RB221-06/07

R602.10.6.1

Proponent: James Bela, Oregon Earthquake Awareness

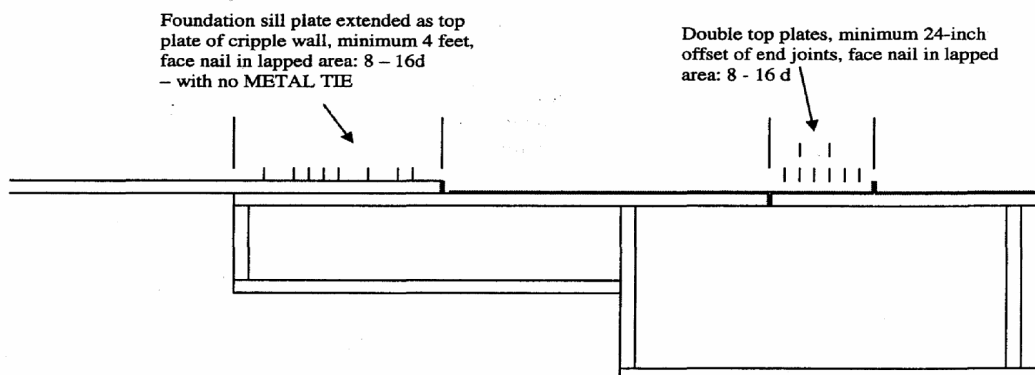
1. Where the height of a required braced wall panel that extends from foundation to floor above varies more than 4 feet (1219 mm), the braced wall panel shall be constructed in accordance with Figure R602.11.3. As an alternative to the metal tie indicated in Figure R602.11.3, the foundation sill plate shall be permitted to extend a minimum of 4 feet as the top plate of the cripple wall attached with 8 – 16d fasteners in the lapped area.

3. ~~2.~~ Where cripple walls occur between the top of the foundation and the lowest floor framing, the bracing requirements ~~for a story of Section R602.10.3~~ shall apply.

4. ~~3.~~ Where only the bottom of the foundation is stepped and the lowest floor framing rests directly on a sill bolted to the foundations, the requirements of Section R602.11.1 shall apply in Seismic Design Category D₂.

This Code Change Proposal adds new text to subparagraph 1, permitting the simple extension of the foundation sill plate "a minimum of 4 feet as the top plate of the cripple wall attached with 8 – 16d fasteners in the lapped area," per TABLE R602.3(1) FASTENER SCHEDULE FOR STRUCTURAL MEMBERS to substitute "as an alternative to the metal tie indicated in Figure R602.11.3." Table R602.3(1) specifies: "Double top plates, minimum 24-inch offset of end joints, face nail in lapped area" – 8-16d (3½" x 0.135"). This puts twice as many 16-d nails in the shorter "minimum 24-inch offset of end joints" of the double top plate than would occur here in "the simple extension of the foundation sill plate 'a minimum of 4 feet as the top plate of the cripple wall attached with 8 – 16d fasteners in the lapped area.'" It is unclear whether the minimum 4 foot lap of the foundation sill plate as the top plate of the cripple wall would still have to comply with: "Double top plates, face nail" – 10 d (3" x 0.128") 24" o.c. See illustration below:

If "Where the height of a required braced wall panel that extends from foundation to floor above varies more than 4 feet (1220 mm)" means "exceeds 4 feet (1219 mm)", the interpretation of FIGURE R602.11.3 STEPPED FOUNDATION CONSTRUCTION is straightforward. But if it means a required length of braced wall panel that is occurring over a "step" (and that the panel height on one side of the step is more than 4 feet (1219 mm) greater than the part of the "length" of braced wall panel on the other side of the step, you get a different (and probably less likely to occur) interpretation.

In any case, thus, this Code Change Proposal eliminates the need for the METAL TIE in any and all circumstances -- by providing "as an alternative to the metal tie indicated in Figure R602.11.3, the foundation sill plate shall be permitted to extend a minimum of 4 feet (1219 mm) as the top plate of the cripple wall attached with 8--16d fasteners in the lapped area." Also, whereas the Model Code language of the 2000, 2003 and 2006 IRC laps "upper top plate" of "the double plate of the cripple stud wall" onto the foundation; this Code Change Proposal does it the opposite way, extending the foundation sill plate along the adjoining cripple wall as the upper top plate.

(Proposed) Figure R.611.8 (8)

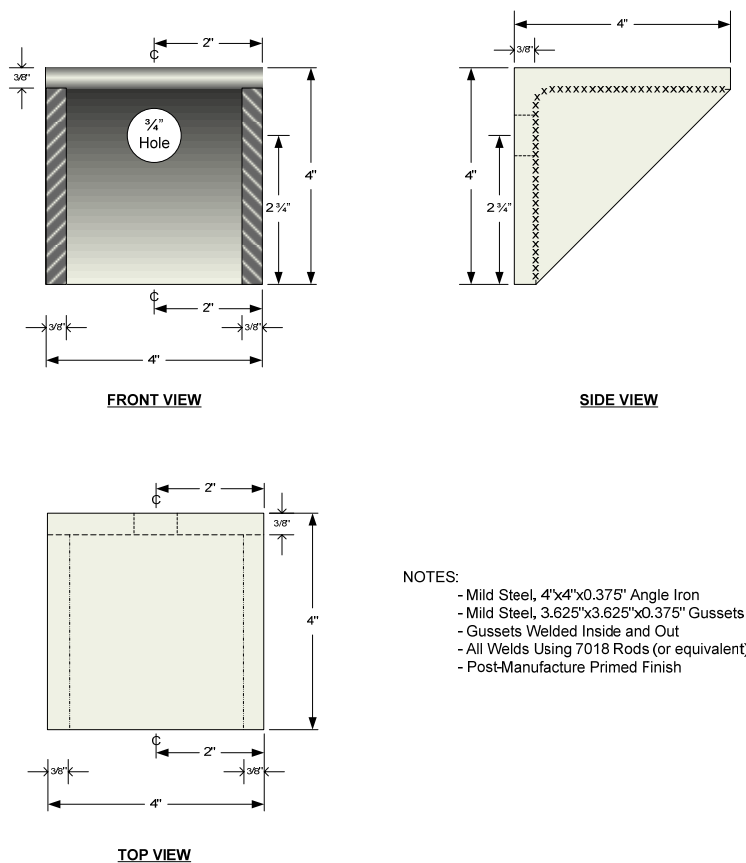
R611.8.2.4 Ledger bearing support brackets. Two inches (2") of the load-bearing ledger boards must bear upon the load-bearing Ledger Support Brackets which shall be spaced per engineer's or architect's specifications in accordance with the relevant I.C.C. regulations. Such ledger support brackets are illustrated in Figure R 611-8(8).
